Model: Perfect Binder GB5000	Date: 20-June -08	No.: RD391001a
-------------------------------------	-------------------	----------------

Subject: Firmware Release Note: P-Binder_B1		Prepared by: T.Tadokoro	
From: PPBG QA/Service Planning Dept.			
Classification:	<input type="checkbox"/> Troubleshooting	<input type="checkbox"/> Part information	<input type="checkbox"/> Action required
	<input type="checkbox"/> Mechanical	<input type="checkbox"/> Electrical	<input type="checkbox"/> Service manual revision
	<input type="checkbox"/> Paper path	<input type="checkbox"/> Transmit/receive	<input type="checkbox"/> Retrofit information
	<input checked="" type="checkbox"/> Other ()

Subject: STAY: Parts catalog correction		Prepared by: T. Tadokoro	
From: PPBG QA/Service Planning Dept.			
Classification:	<input type="checkbox"/> Troubleshooting <input type="checkbox"/> Mechanical <input type="checkbox"/> Paper path <input type="checkbox"/> Other ()	<input checked="" type="checkbox"/> Part information <input type="checkbox"/> Electrical <input type="checkbox"/> Transmit/receive	<input type="checkbox"/> Action required <input type="checkbox"/> Service manual revision <input type="checkbox"/> Re

11. Inserter Section 5 (D391)

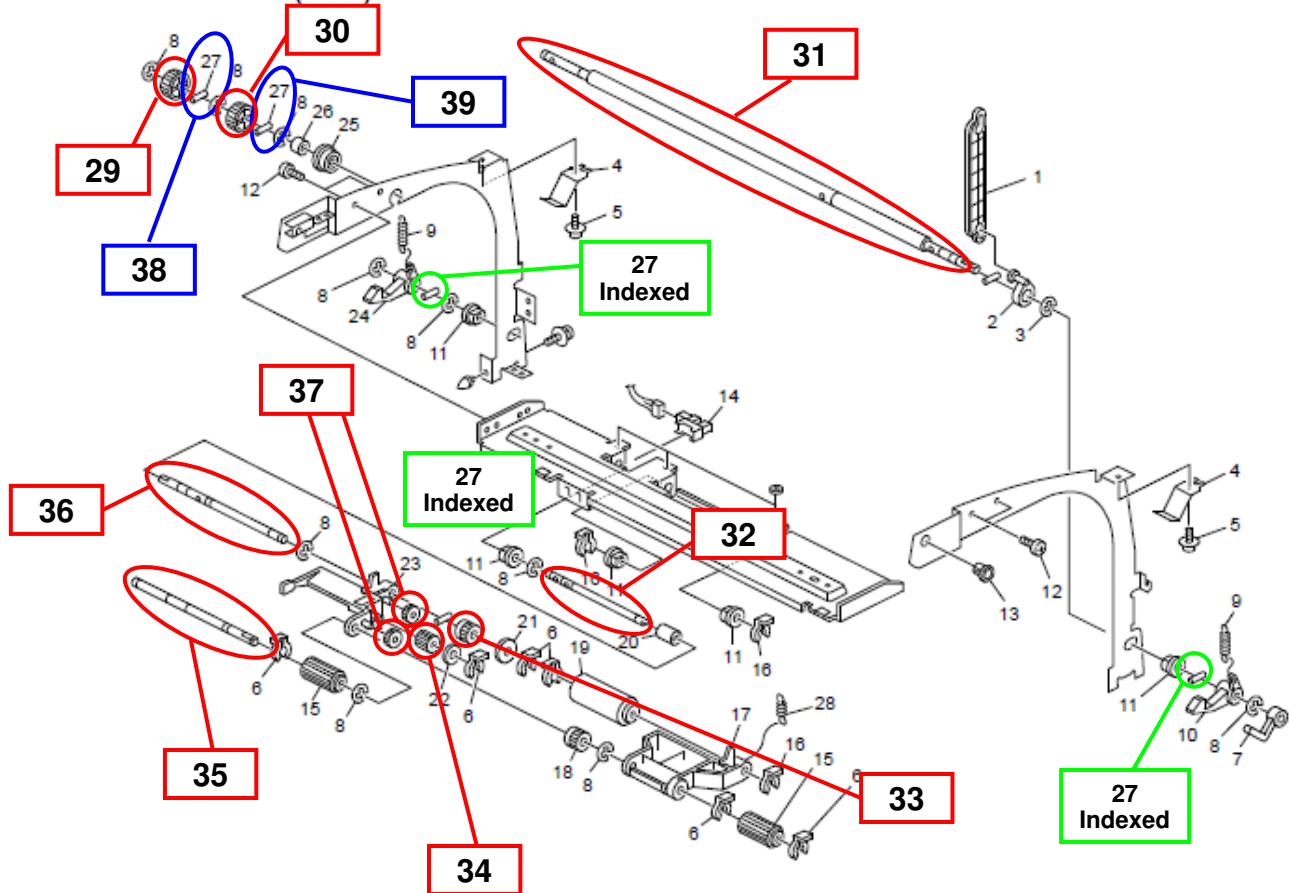
Part Number	Description	Q'ty	Int	Page	Index	Note
D3911154 → D391155	PARALLEL PIN:2X14:HP020140SCH	2 → 1	-	23	27 → 38	Correction
D3911154 → B6604715	PARALLEL PIN:HP020120SCH	2 → 1	-	23	27 → 39	Correction

12.Inserter Section 6 (D391)

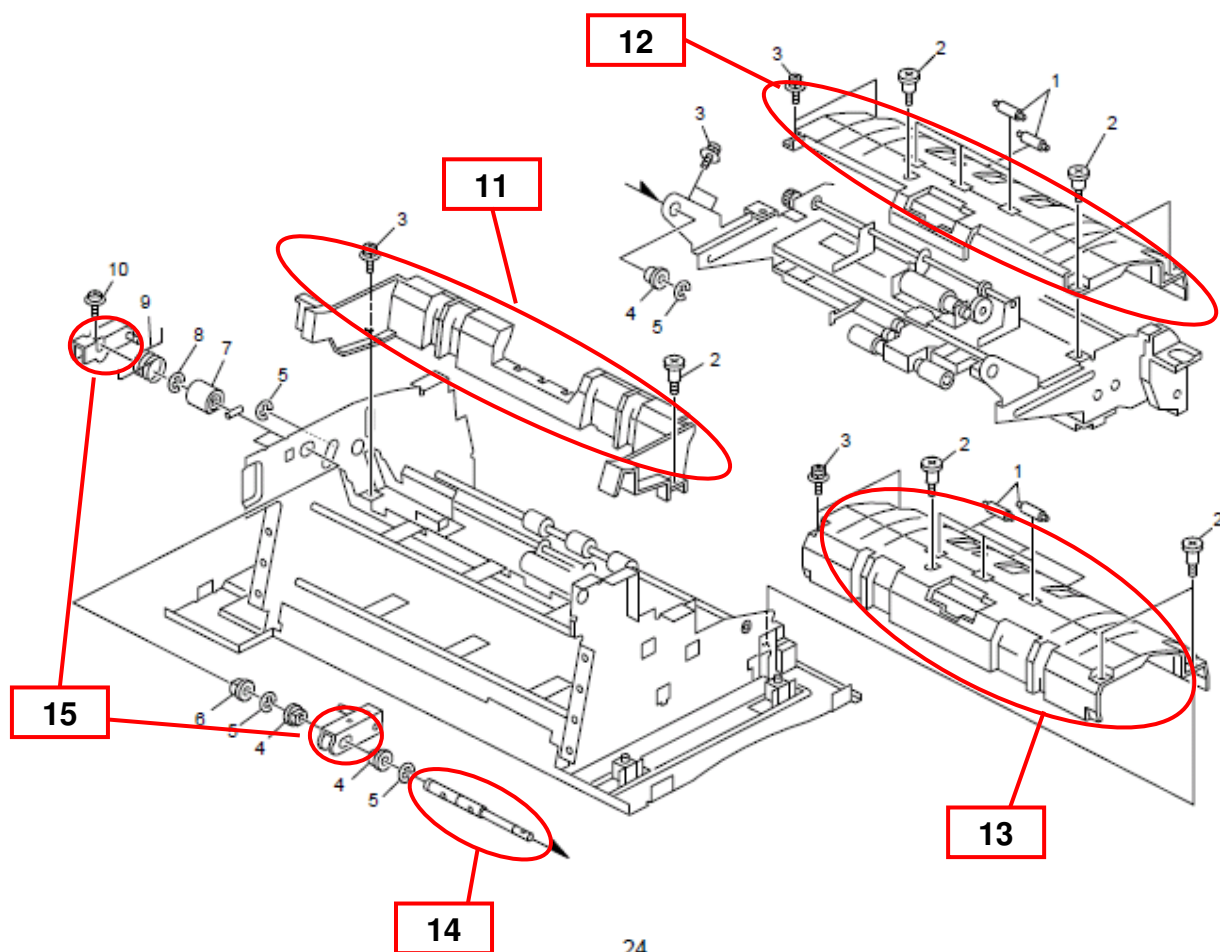
New Part Number	Description	Q'ty	Int	Page	Index	Note
D3911597	GUIDE:BIN:UPPER:PF3099P009	1	-	25	11	Add
D3911598	GUIDE:INNER:BIN:UPPER:PF3099K100	1	-	25	12	Add
D3911599	GUIDE:INNER:BIN:PF3099K101	1	-	25	13	Add
D3911600	SHAFT:COUPLING:PF3091P211	1	-	25	14	Add
D3911601	BRACKET:AUXILIARY:COVER:PF3091K013	2	-	25	15	Add

13.Inserter Section 7 (D391)

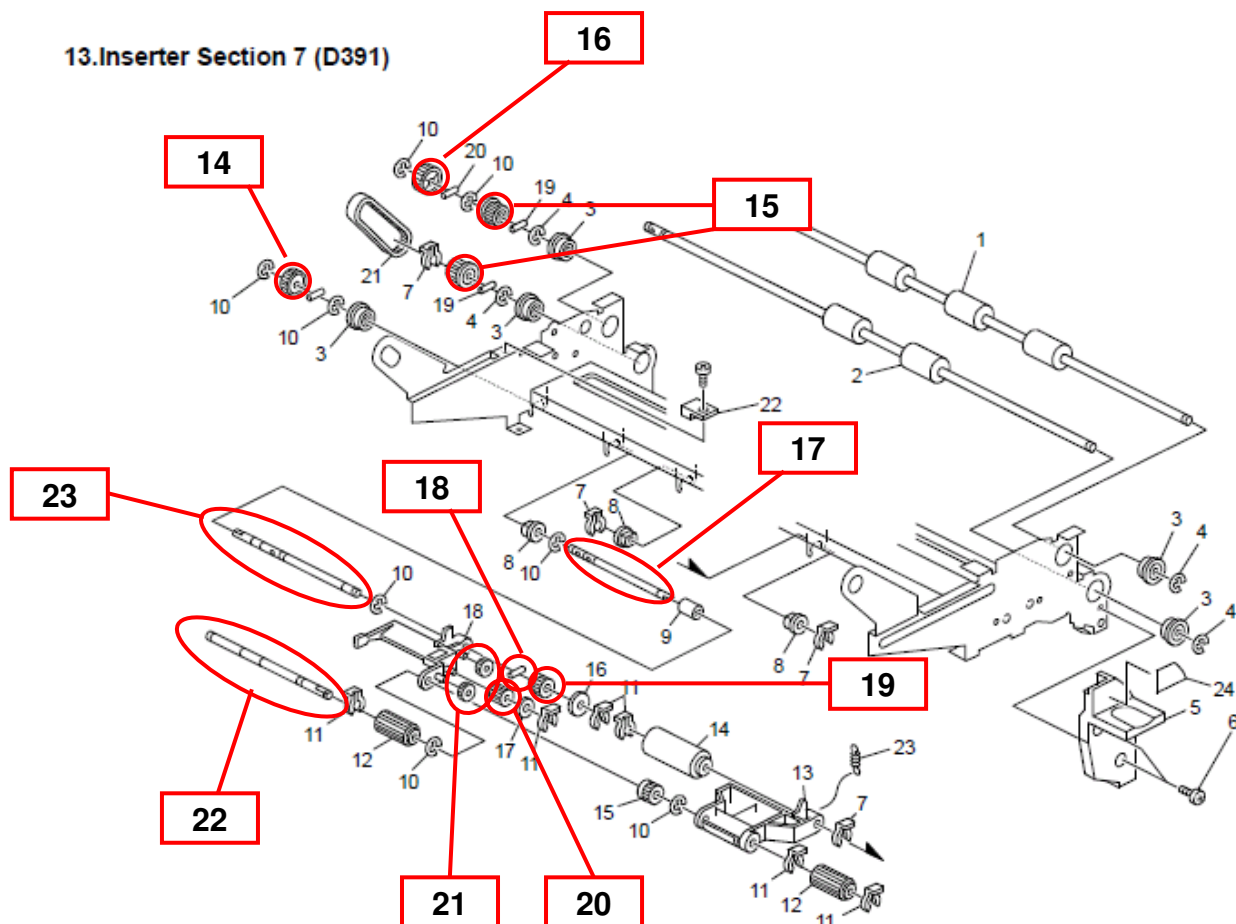
New Part Number	Description	Q'ty	Int	Page	Index	Note
D3911602	GEAR:Z20:PF3091P405	1	-	27	14	Add
D3911532	TIMING PULLEY:Z18XS3M:PF4051P056	2	-	27	15	Add
D3911589	GEAR:Z26:PF4051P025	1	-	27	16	Add
D3911591	SHAFT:COUPLING:FEED ROLLER: PF3091P204	1	-	27	17	Add
D3911154	PARALLEL PIN:2X10:HP020100SCH	1	-	27	18	Indexed
D3911592	GEAR:Z22:PF3091P056	1	-	27	19	Add
D3911593	GEAR:Z18:PF3091P099	1	-	27	20	Add
D3911596	GEAR:Z18:PF3091P054	2	-	27	21	Add
D3911594	SHAFT:PICKUP ROLLER:PF3091P206	1	-	27	22	Add
D3911595	SHAFT:FEED ROLLER:PF3091P203	1	-	27	23	Add

14. Inserter Section 8 (D391)

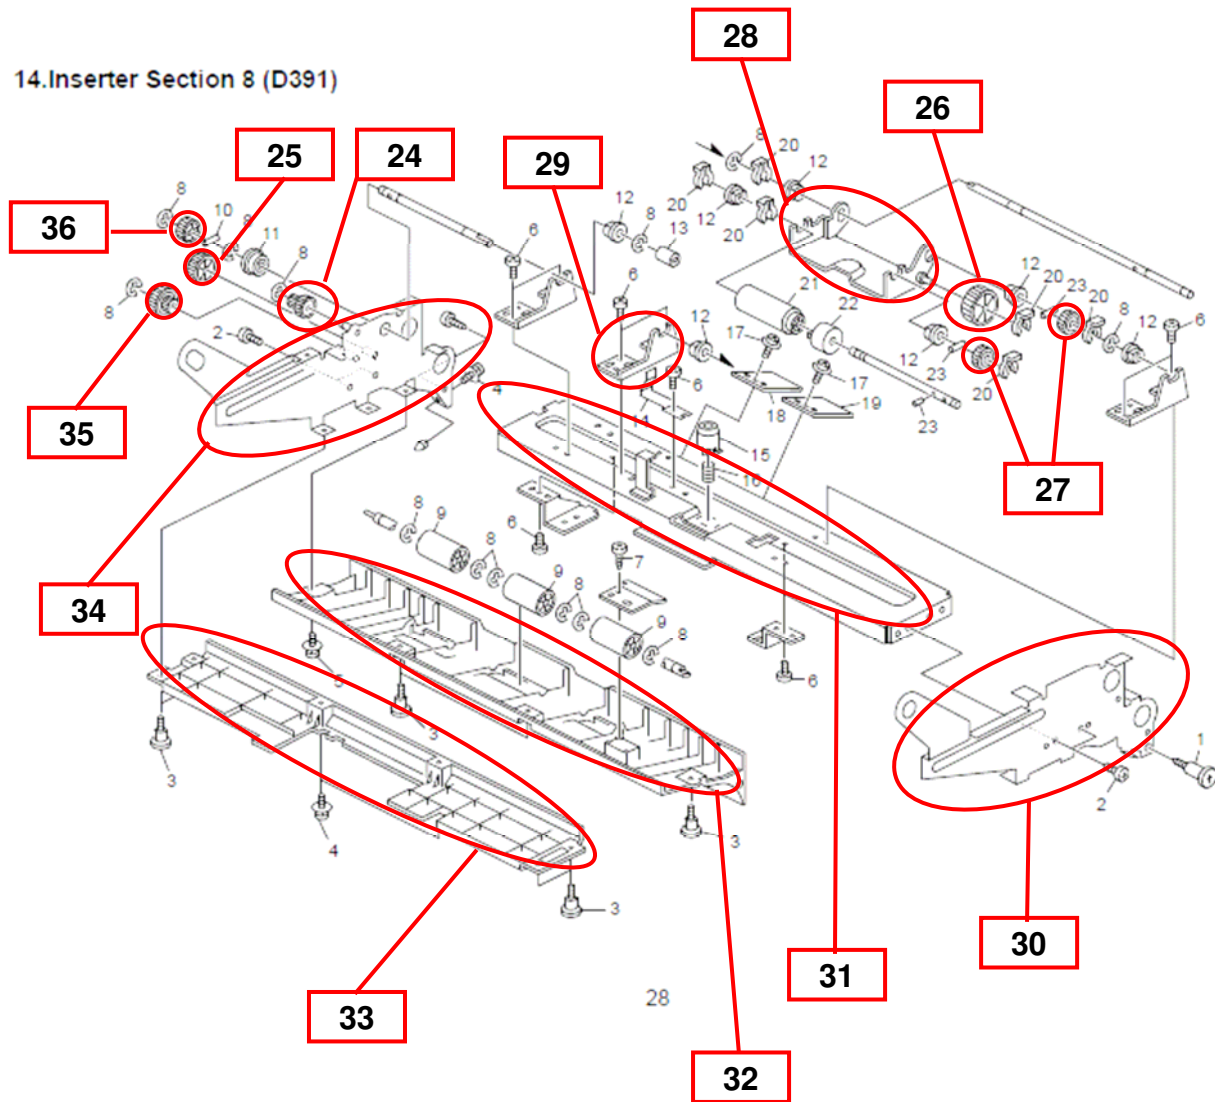
New Part Number	Description	Q'ty	Int	Page	Index	Note
D3911603	GEAR:Z20/Z14:PF3091P063	1	-	29	24	Add
D3911604	GEAR:Z28:PF3091P065	1	-	29	25	Add
D3911605	GEAR:Z49:PF3091P098	1	-	29	26	Add
D3911596	GEAR:Z18:PF3091P054	2	-	29	27	Add
D3911606	BRACKET:SUPPORT:ROLLER:PF3091K104	1	-	29	28	Add
D3911607	GUIDE PLATE:SHAFT:SEPARATION: PF3091P183	1	-	29	29	Add
D3911608	SIDE PLATE:FRONT:PF3091P105	1	-	29	30	Add
D3911609	STAY:MAIN:PF3091P107	1	-	29	31	Add
D3911610	GUIDE:BIN:PF3099K105	1	-	29	32	Add
D3911611	GUIDE:PICKUP:BIN:LOWER:PF3091K175	1	-	29	33	Add
D3911612	SIDE PLATE:REAR:PF3091K003	1	-	29	34	Add
D3911602	GEAR:Z20:PF3091P405	1	-	29	35	Add
D3911613	GEAR:Z28/14:PF3091P062	1	-	29	36	Add

15.Inserter Section 9 (D391)

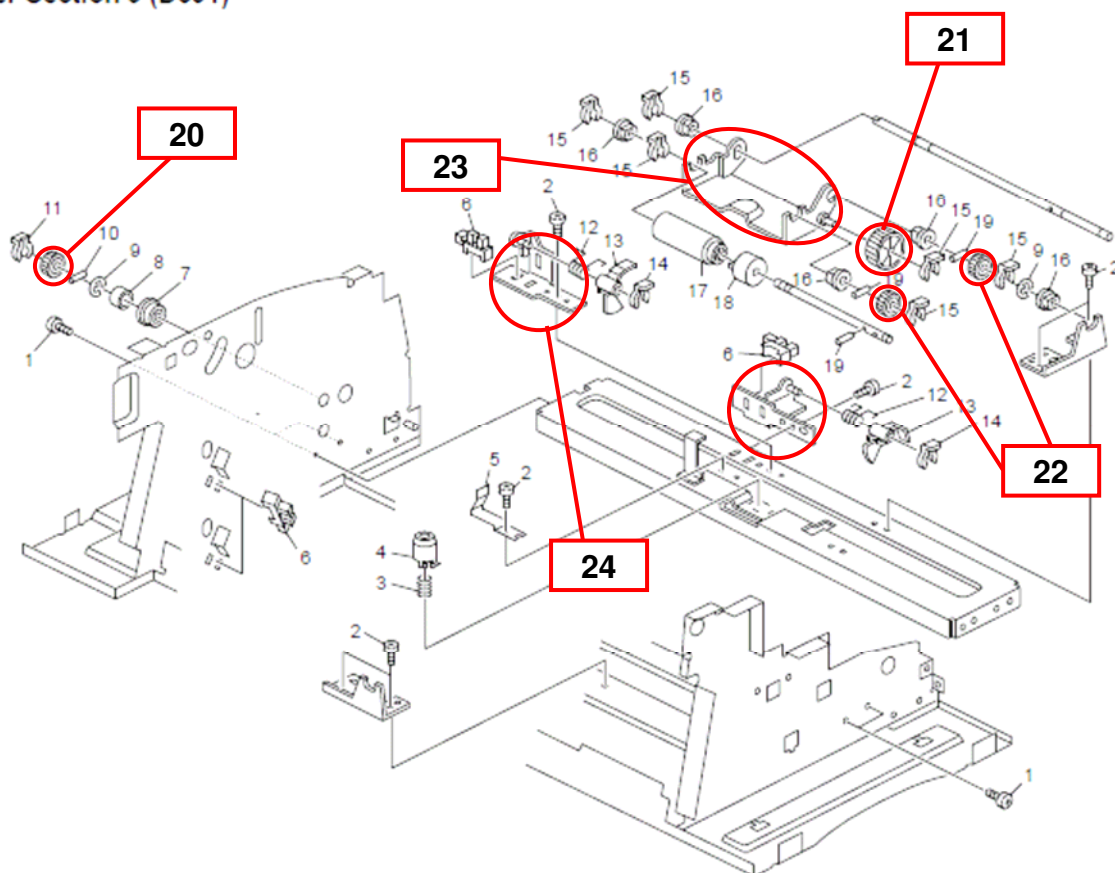
New Part Number	Description	Q'ty	Int	Page	Index	Note
D3911602	GEAR:Z20:PF3091P405	1	-	31	20	Add
D3911605	GEAR:Z49:PF3091P098	1	-	31	21	Add
D3911596	GEAR:Z18:PF3091P054	2	-	31	22	Add
D3911606	BRACKET:SUPPORT:ROLLER:PF3091K104	1	-	31	23	Add
D3911614	BRACKET:REGISTRATION SENSOR: PF3091K008	1	-	31	24	Add

16. Inserter Section 10 (D391)

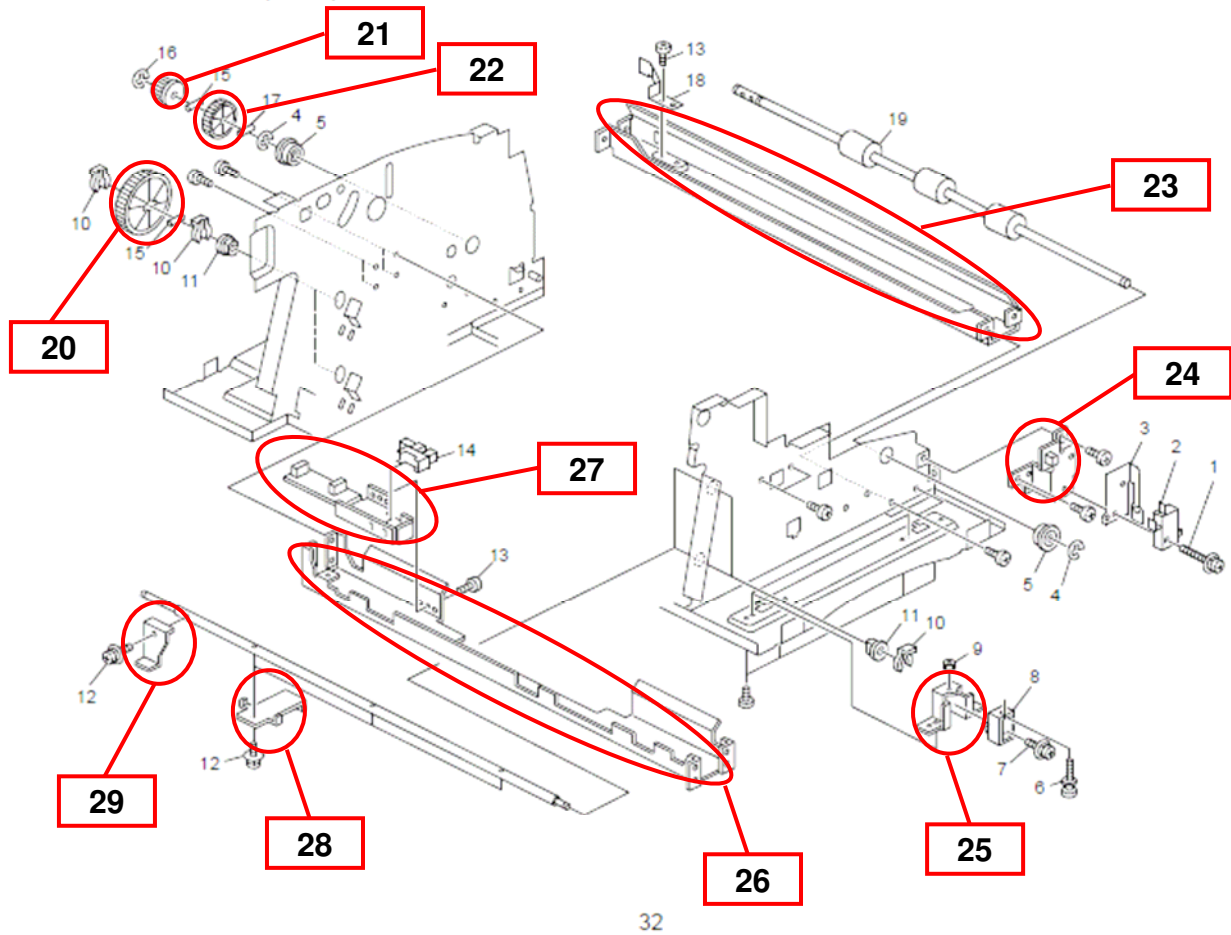
New Part Number	Description	Q'ty	Int	Page	Index	Note
D3911615	GEAR:Z74:PF3091P089	1	-	33	20	Add
D3911532	TIMING PULLEY:Z18XS3M:PF4051P056	1	-	33	21	Add
D3911616	GEAR:Z35:PF3091P088	1	-	33	22	Add
D3911617	GUIDE:EXIT:PF3091P115	1	-	33	23	Add
D3911618	BRACKET:SENSOR:ON OFF DETECTOR: PF3091P146	1	-	33	24	Add
D3911619	BRACKET:ADJUSTING PIN:PF3091P134	1	-	33	25	Add
D3911620	FRAME:BIN:LOWER:PF3091K018	1	-	33	26	Add
D3911621	BRACKET:SENSOR:BIN:LOWER: PF3091P144	1	-	33	27	Add
D3911622	BRACKET:RISE:PF3091P137	1	-	33	28	Add
D3911623	BRACKET:SENSOR:PF3091P141	1	-	33	29	Add

17.Inserter Section 11 (D391)

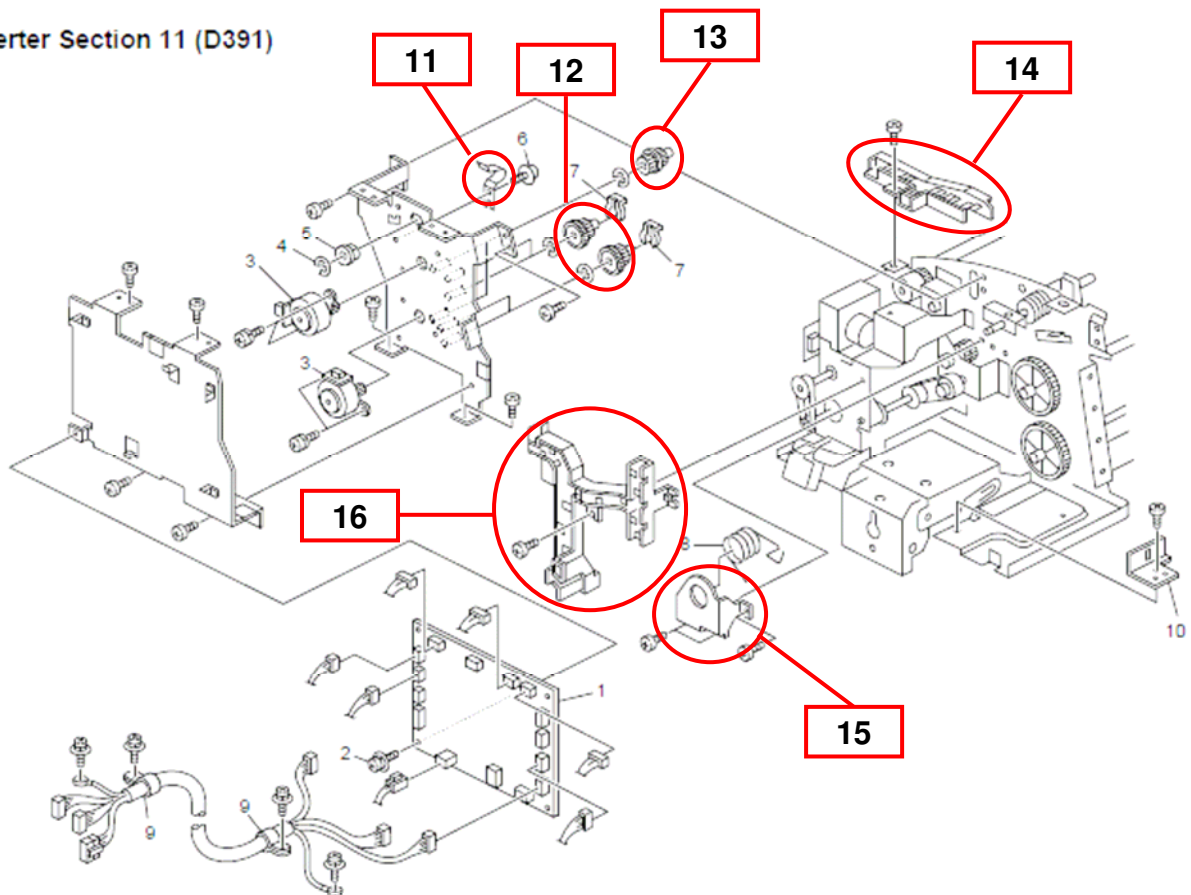
New Part Number	Description	Q'ty	Int	Page	Index	Note
D3911624	SPRING PLATE:LOCK:PF2214P455	1	-	35	11	Add
D3911625	GEAR:Z16/Z28:PF4090P241	2	-	35	12	Add
D3911626	GEAR:Z28/Z16:PF3091P086	1	-	35	13	Add
D3911627	DUCT:UPPER:PF3091P095	1	-	35	14	Add
D3911628	HOLDER:COIL SPRING:AUXILIARY: PF3091P176	1	-	35	15	Add
D3911629	DUCT:MAIN:PF3091P094	1	-	35	16	Add

18. Inserter Section 12 (D391)

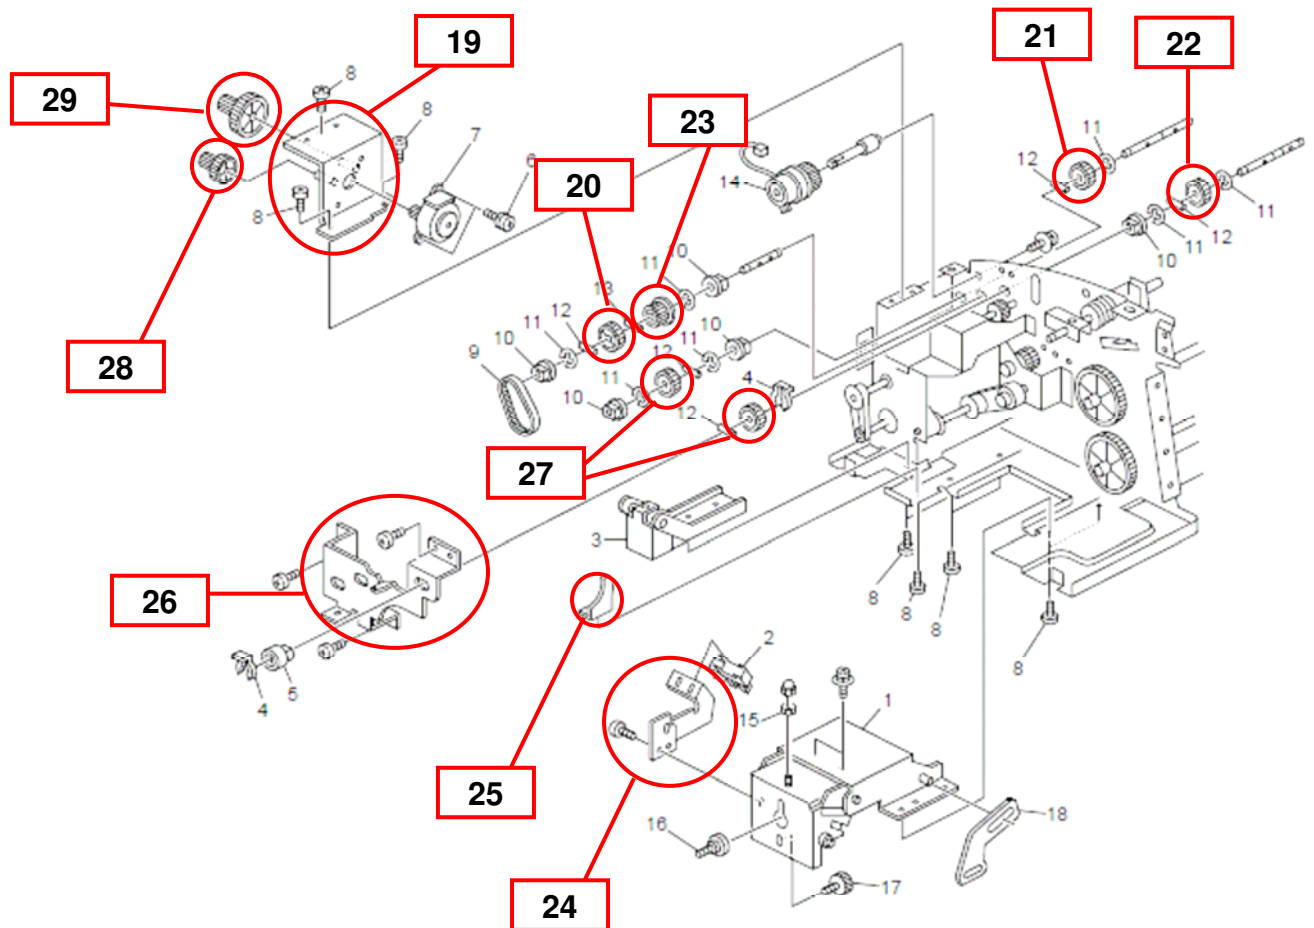
New Part Number	Description	Q'ty	Int	Page	Index	Note
D3911630	BRACKET:DC STEPPER MOTOR: PF3091K010	1	-	37	19	Add
D3911604	GEAR:Z28:PF3091P065	1	-	37	20	Add
D3911631	GEAR:Z18:PF3091P069	1	-	37	21	Add
D3911632	GEAR:Z20:PF3091P067	1	-	37	22	Add
D3911532	TIMING PULLEY:Z18XS3M:PF4051P056	1	-	37	23	Add
D3911633	BRACKET:SENSOR:ON OFF DETECTOR: PF3091P150	1	-	37	24	Add
D3911634	BRACKET:SENSOR:ON OFF DETECTOR: PF3091P149	1	-	37	25	Add
D3911635	BRACKET:DRIVE:REGISTRATION: PF3091P127	1	-	37	26	Add
D3911602	GEAR:Z20:PF3091P405	2	-	37	27	Add
D3911636	GEAR:Z16/Z40:PF3091P404	1	-	37	28	Add
D3911637	GEAR:Z16/Z60:PF3091P407	1	-	37	29	Add
